MEMORANDUM

Title: Notes on As-Built Pin Valving for the HEPI Actuator
Refer to: LIGO-T040078-01
Date: 27 April 2004
Author: Dennis Coyne

Figure 2: Actuation Plate Hole Dimensions (D020285-A with Revision B markups indicated)

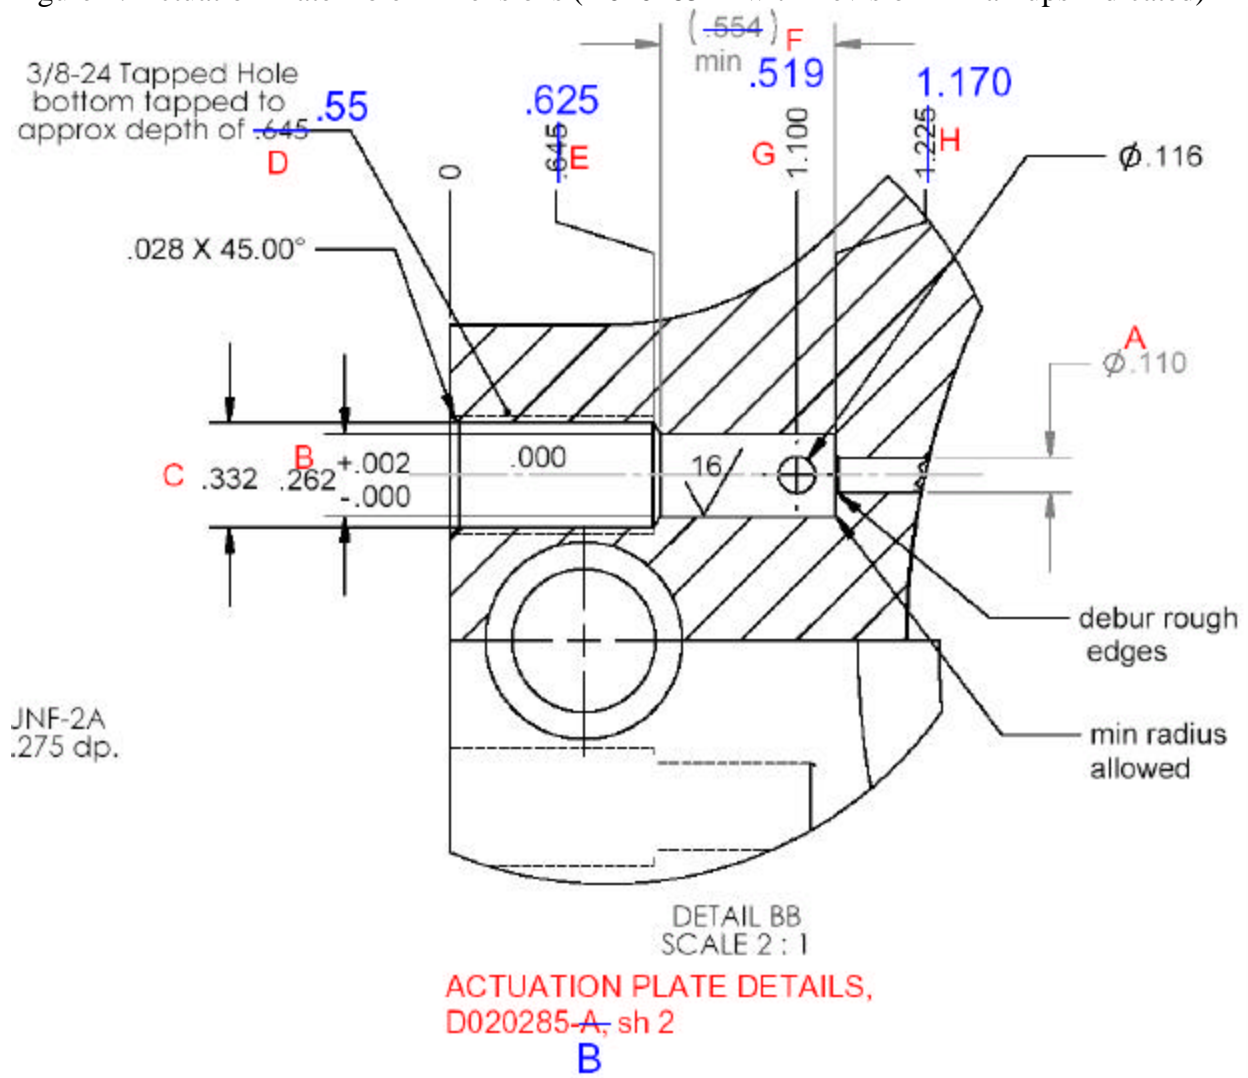
- a) Revised small pin dimensions per revision B of D020359. Revision B was used for the production but not (yet) filed in the DCC.
- b) Revised small pin hole dimensions in the actuator plate per revision B of D020285. Revision B was used for the production but not (yet) filed in the DCC.
- c) Revised small pin hole dimensions in the manifold plate per revision B of D020300. Revision B was used for the production but not yet filed in the DCC.
- d) Added notes on serrated edges at sealing point and chips found in a few holes, burrs at side port in a few holes.
- e) Added measurements/tests on 5 other actuators (6 total)
- f) Revised the recommended modifications to the small pin valves

The bottom of the pin valve bore (nominal 0.262" diameter), which forms the sealing edge (with the nominal 0.110 through hole orifice), has significant chatter in many of the actuator plate

holes. This makes the sealing edge serrated. While this may prevent a perfect seal, it is deemed acceptable since small leakage (weeping) past the pin valves in actuator run mode is acceptable.

Figure 4: Small Pin Dimensions (D020359-C, sh 1) [Proposed Revision]

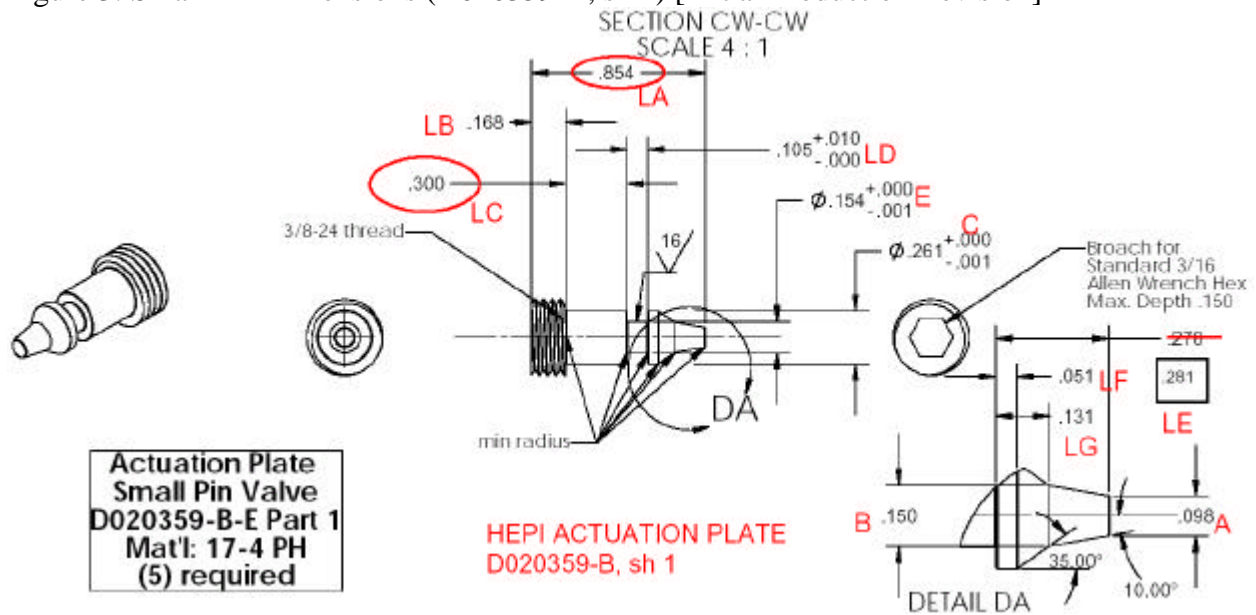
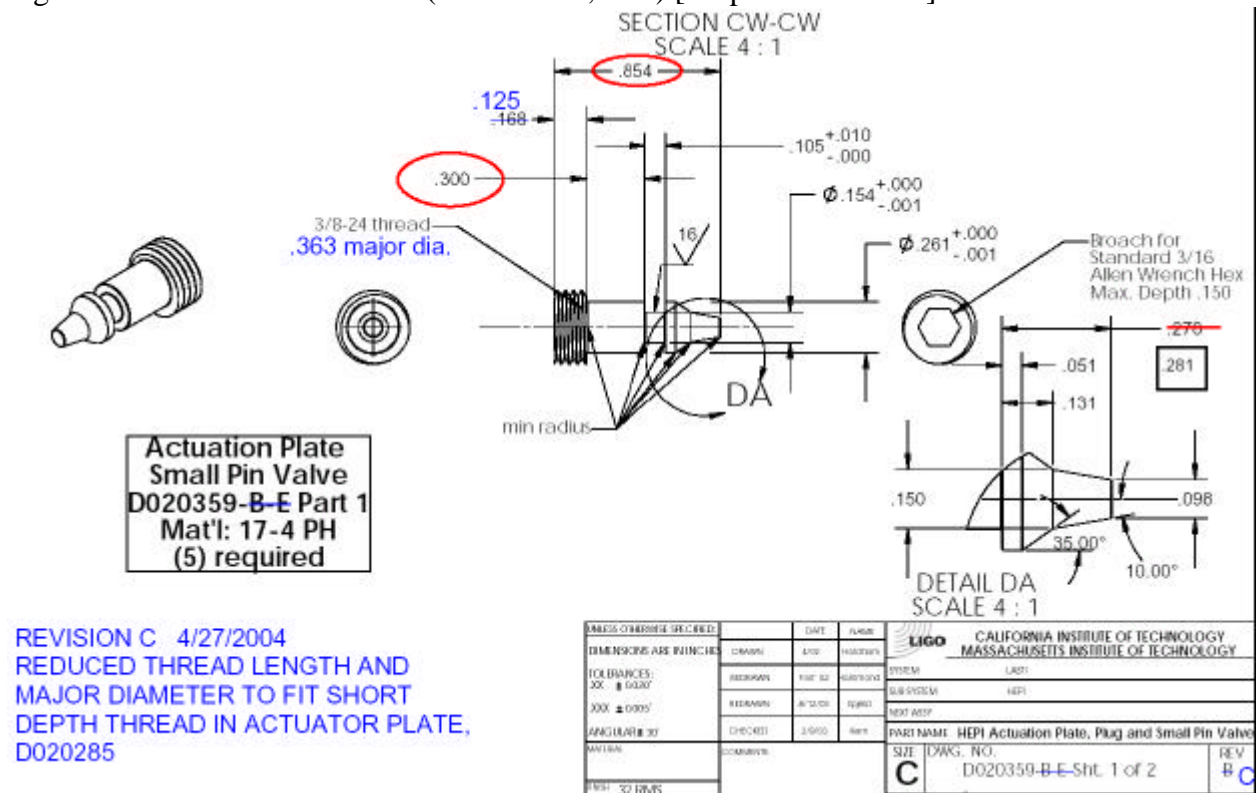
The small pins do not properly seat against their conical tips. This is based on two observations:

The manufacturer for the machined parts of the actuator was supposed to confirm that the pin valves seated properly (using marker on the conical tip), but failed to catch this problem. The problem is basically a design problem with too little tolerance allowed for thread depth (nominal dimensions work with a 0.031" tolerance). While a minimum length of the o-ring bore length (nominal 0.262" dia.) was specified, an equally important maximum length (or conversely minimum thread depth) was not specified. The marker test that the pin valves seat properly should have caught this problem when the parts were inspected and before welding into the actuator assembly.

- 0) Check all bores and remove side port burrs and metal chips.
- 1) Modify the existing pins as follows (revision C, see figure 4):
 - a) reduce the threaded region length by 0.043" (from 0.168" to 0.125") by lathing off about 1 thread, thereby increasing the piston length. This will leave 3 threads remaining.
 - b) lathe down the thread major diameter to 0.363" (from 0.373"). This is the minimum diameter for a 3/8 – 24 UNF thread.
